BGA TECHNICAL COMMITTEE

TECHNICAL NEWSHEET 11/12/99

**Airworthiness
Directive
1999-340**

Subject: Cracks in the aileron steel pipe around the welded in hinge bushings (3 at each aileron)

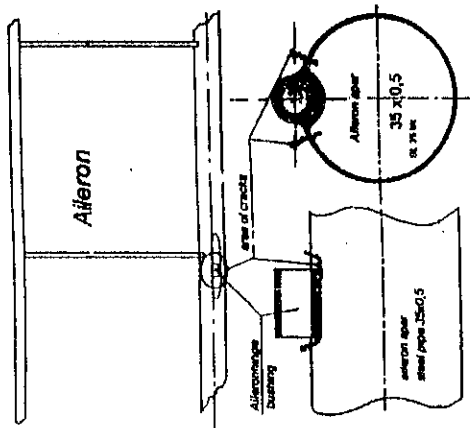
Reason: During inspection of a motorglider one aileron hinge was found to be broken out of the aileron steel pipe spar. On one aileron hinge bushing of another motorglider cracks have been detected around the hinge bushing weld seam (see following sketch)

- 1. Ailerons of affected motorgliders must be removed. Inspection of the welded seams of the aileron hinges and of the areas around the hinges is to be made with a ten-times magnifying glass. Therefore fabric and painting are to be removed 50 mm around the aileron hinge bushings on the aileron spar. If no cracks are found, paint the aileron spar steel pipe and repair the removed fabric. Following this inspection pay special attention during each maintenance inspection to point 6a of the manufacturer's check list SF 25 last edition.

- 2. If cracks are found aileron hinge bushings must be reinforced in accordance with the following sketch.
If cracks are detected around an aileron hinge bushing or if a hinge bushing is worn out, corrosion inspection of the inside of the aileron spar steel pipe is requested, because moisture may have appeared in period of time.
If corrosion is detected inside the aileron spar steel pipe please contact SCHEIBE Flugzeugbau GmbH for special repair instructions.
If one aileron hinge bushing must be reinforced all three hinge bushings on both ailerons of the motorglider must be reinforced. After reinforcing of the hinge bushings by a steel sheet joint (see the following sketch) special inspections according to point 6a of the manufacturer's maintenance checklist last edition will no longer be necessary.

Reinforcement sheet joint

Remarks: Take care for a correct alignment of the welded in aileron hinge bushings with the wingside hinge bolts.
Actions to be accomplished by an approved aeronautical workshop, an approved JAR 145 organisation or by the manufacturer, provided licenced aviation welding personnel is available.

KA 7. RUDDER CABLE. Potential Foul.

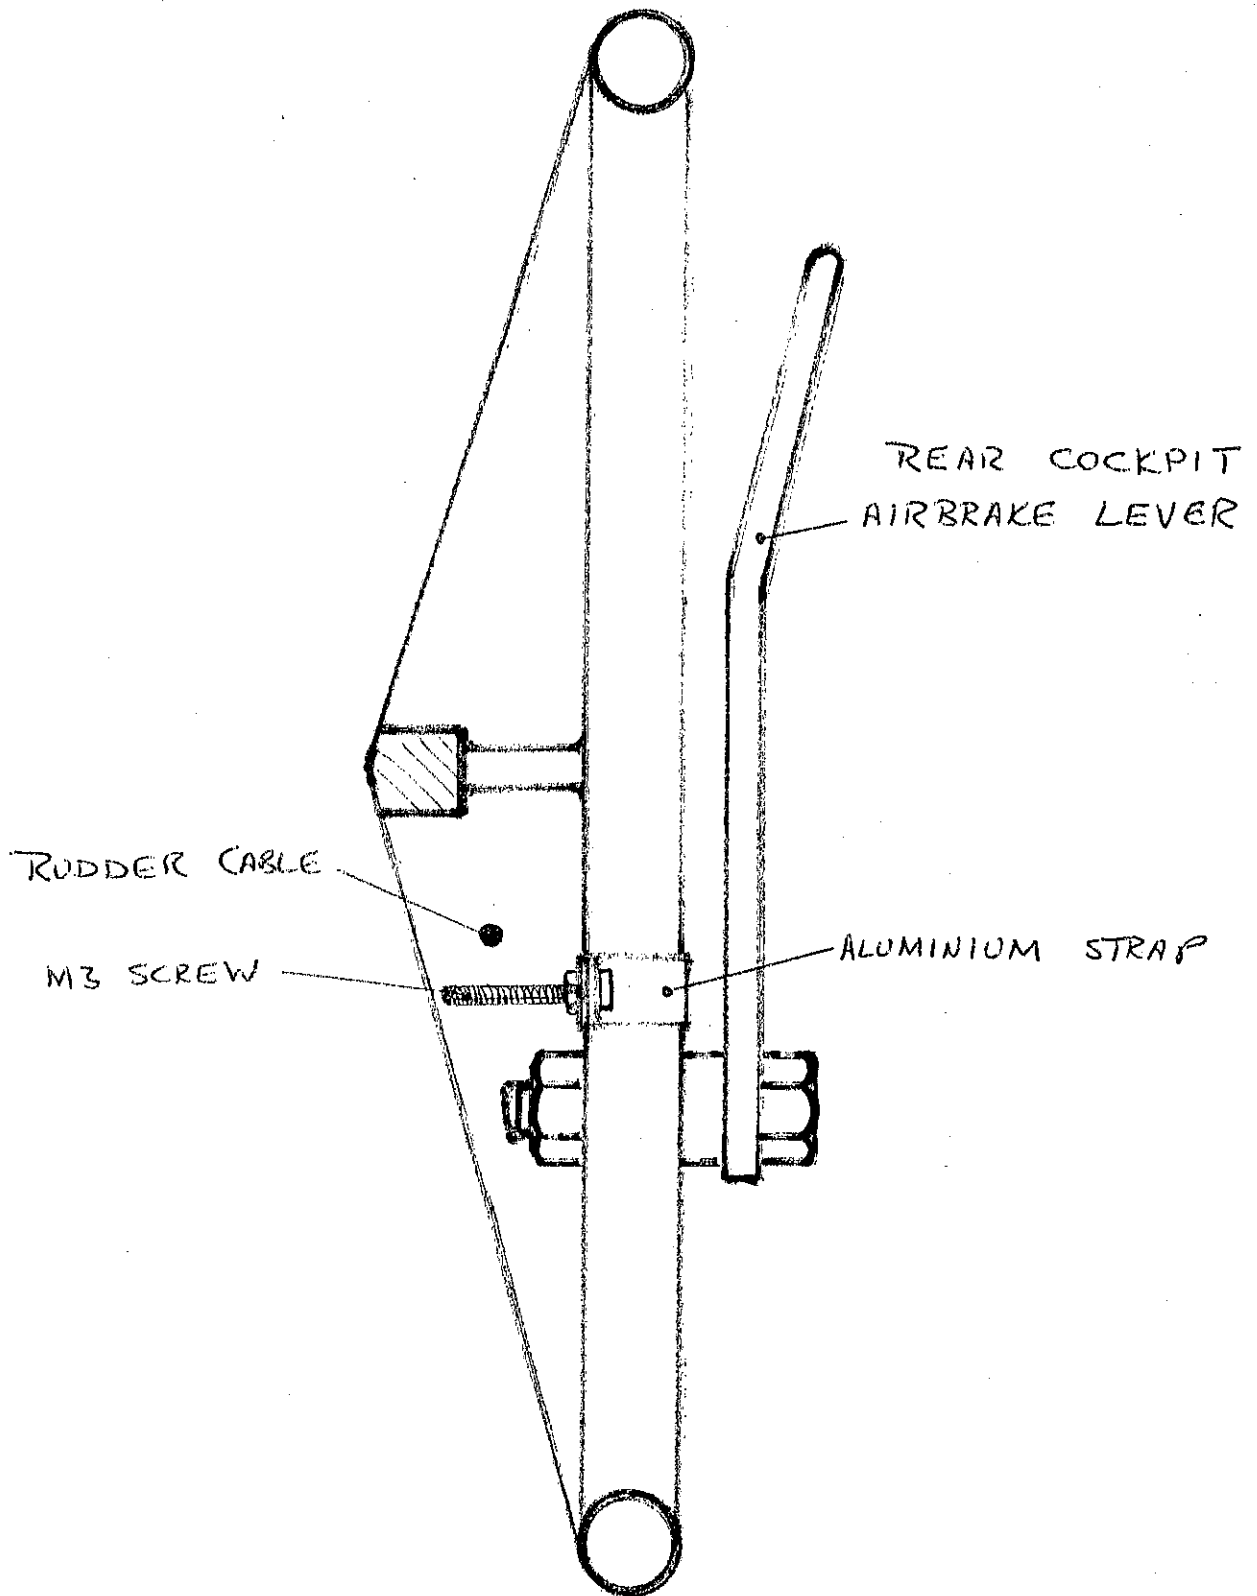
PART SECTION THROUGH FUSELAGE (FROM REAR)

Drawing 5L36

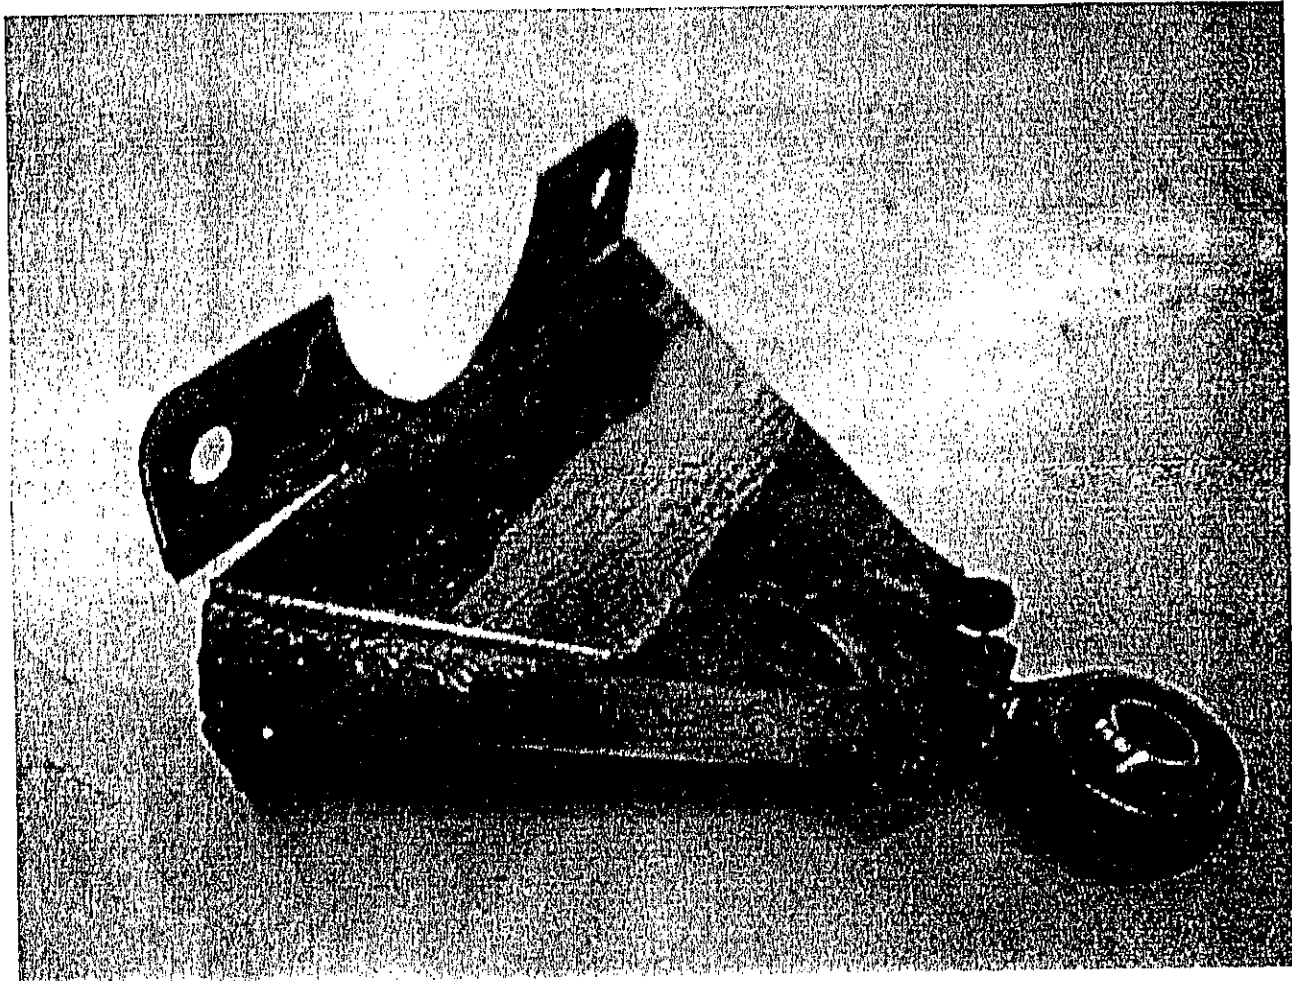
Stiffening of the stand for the elevator control pushrod guide in the vertical fin

6. Prepare a dia. 2mm pianowire according to the sketch on drawing 5L36.
7. Scratch out the foam 6mm (.24in.) around the hole, from both the shear web and the stand. Enlarge this hole up to the aluminium tube of the push rod guide. No foam shall remain at the tube in the area of the hole.

1. Remove the rudder.
2. a) Gliders with fin battery installed: In the centre of the fin trailing edge shear web you will find the end of the battery box drain line. Make a mark 15mm below the centre of the drain line on the centre line of the shear web.

b) Powered sailplanes: Measure from the lower edge of the upper rudder stand 555 mm (21.9 in.) downwards to make the mark.
3. Cover and tape the Mylar seals on both sides each with a piece of cardboard or similar in the working area to protect the seals and to secure your hands from being injured by the sharp ends of the seals.

4. Use a dia. 10mm drill. Wrap some layers of tape around the drill 16mm away from its tip.
5. Carefully drill a hole into the shear web at the marking until the tape touches the shear web.

8. Roughen the shear web over its whole width 30mm above and below the hole.
9. Apply mixture of resin and hardener to the roughened surface and the inside of the hole including the aluminium tube.

10. Mix cottonflocks to the resin and fill the prepared hole completely.
11. Cover the hole with a piece of glassfibre fabric style 92125 laid up diagonally 70mm (2.8 in.) wide and 50mm (2 in.) high.
Gliders with fin battery installed: cut off the edge of this fabric at the drain hole so as not close the hole.

12. Allow to cure at room temperature. Then postcure for min. 18 hours with 54°C. Use a hot air gun, direct the hot air from behind onto the repaired area. Take care to give sufficient distance between the gun and the surface and check the temperature at the repaired surface.
We recommend to protect the inside of the fin trailing edge with a heat resistant insulating fabric (e.g. as used for soldering or welding) to prevent deformation of the material.

13. Execute a control check of the elevator control.
14. Reinstall the rudder using new split pins.
